# Access Compliance Report

## Public Rights-of-Way (Curb Ramps)

Intersection ID: 53231	Main Street: MORGAN_CLARK_RD	Cross Street: FLEETWOOD_DR	Location: SW
ADA ID: EC1CAADEA74	Ramp Type: Perp	Initial Pass/Fail: Fail	Overall Compliance: No
			Severity Score: 13.75

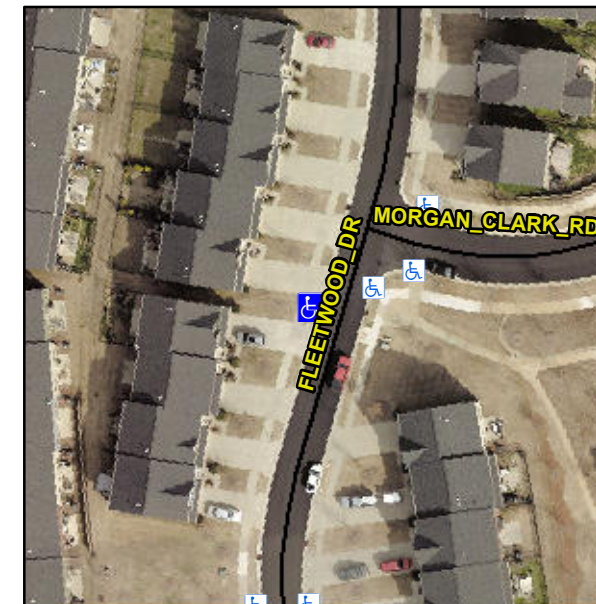
**Not Found, R304.2.2**

Compliance	Description	Data	Compliance	Description	Data
N/A	Ramp Length (in)	59.0	No	Ramp Slope (%)	8.5
Yes	Ramp Width (in)	48.0	Yes	Ramp XSlope (%)	2.9
N/A	Flare Type LT	N/A	N/A	Flare Type RT	N/A
N/A	Flare Slope LT (%)	N/A	N/A	Flare Slope RT (%)	N/A
N/A	Flare Traversable LT?	N/A	N/A	Flare Traversable RT?	N/A
N/A	Landing Length (in)	N/A	N/A	DWS Provided?	N/A
N/A	Landing Width (in)	N/A	N/A	DWS Contrast?	N/A
N/A	Landing Slope (%)	N/A	N/A	DWS Length (in)	N/A
N/A	Landing X Slope (%)	N/A	N/A	DWS Full Width?	N/A
N/A	Landing Curb? (Y/N)	N/A	N/A	DWS Offset (in)	N/A
N/A	Shared Landing?	N/A			
N/A	Gutter Ponding?	N/A	N/A	Gutter Slope (%)	N/A
N/A	Gutter Lip Ht (in)	N/A	N/A	Gutter X Slope (%)	N/A
N/A	Painted X Walk1?	No	N/A	Painted X Walk2?	N/A
	X Walk 1 Direction	To E		X Walk 2 Direction	N/A
N/A	X Walk 1 Width (in)	N/A	N/A	X Walk 2 Width (in)	N/A
	X Walk 1 Slope (%)	2.6		X Walk 2 Slope (%)	N/A
	X Walk 1 X Slope (%)	3.8		X Walk 2 X Slope (%)	N/A

**Remove & Replace Entire Ramp.**
